1963 - 1965 Corvette: Service Bulletin: Drive Line Noise

Subject: Drive Line Noise
Model and Year: 1963 - 1965 Corvette
Source: Chevrolet Technical Service Bulletin
Bulletin No: #1069
Section: IV
Date: January 7, 1965

FIGURE 1

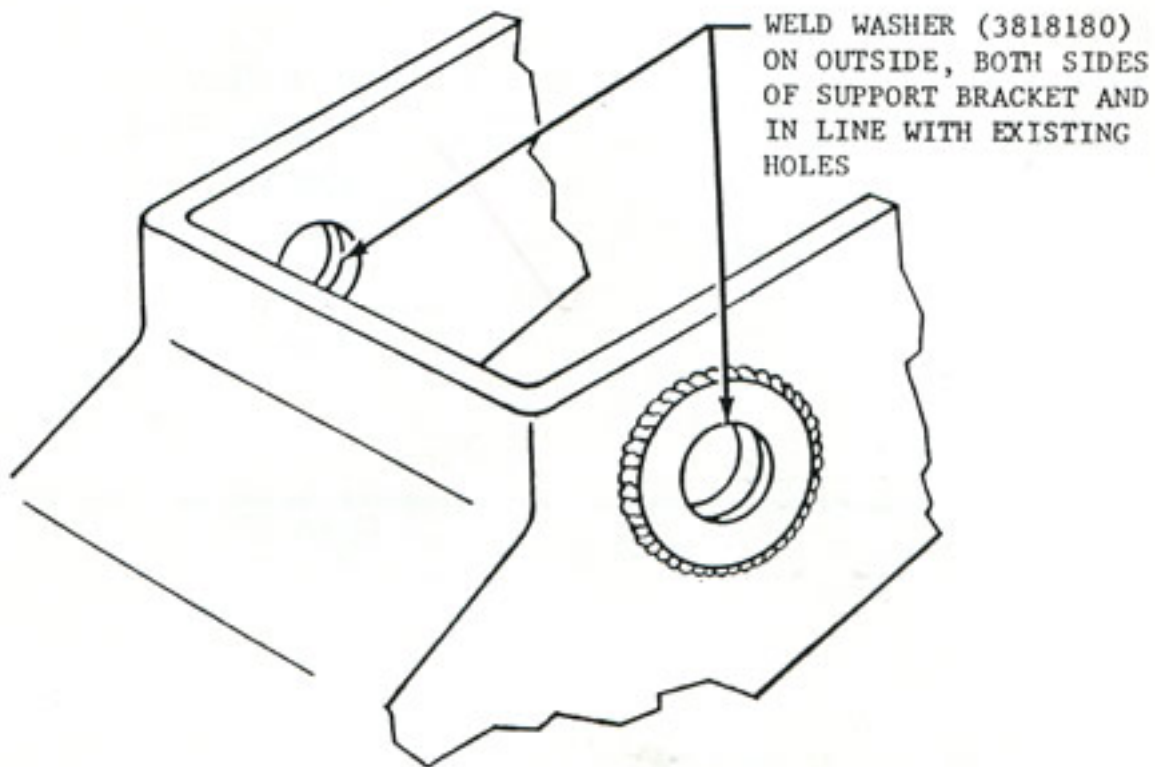
PART I - Re-work of Bracket Part No. 3820186

1. If reinforced bracket, Part No. 3868799 is not available, obtain Part No 3820186 and weld one flat washer, (Part No. 3818180) on each outside surface in line with existing holes (See Figure 1.)

FIGURE 2

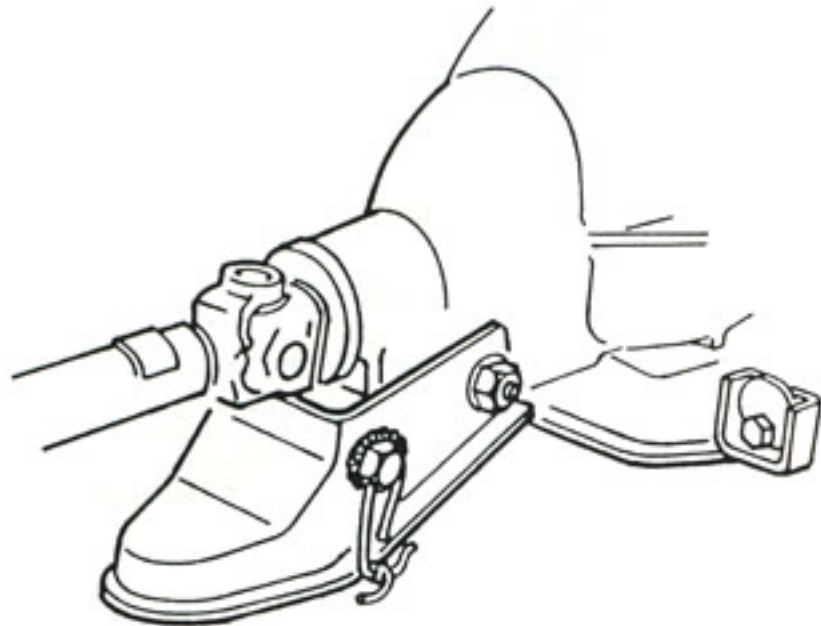
1. Obtain (2) 7/16-14 x 1 300M bolts and drill a 3/32 inch diameter hole through the head of each.
2. Drill a 3/32 inch diameter hole through the lower flange of the carrier bracket directly below the forward bolt hole (both sides of bracket).

3. Install new bracket using modified forward attaching bolts. Torque forward attaching bolts to 65 ft. lbs.
4. Safety wire the forward bracket bolts to the bracket with stainless steel safety wire (1/16 inch O.D.) or stainless steel welding rod (1/16 inch O.D.).

NOTE: Be sure the straight wire form the bolt head to the flange hole is on the tightening side of the bolt. (See Figure 2).

5. Tighten the wire sufficiently by twisting the ends together. NOTE: Over-tightening will cut the wire at sharp bends.
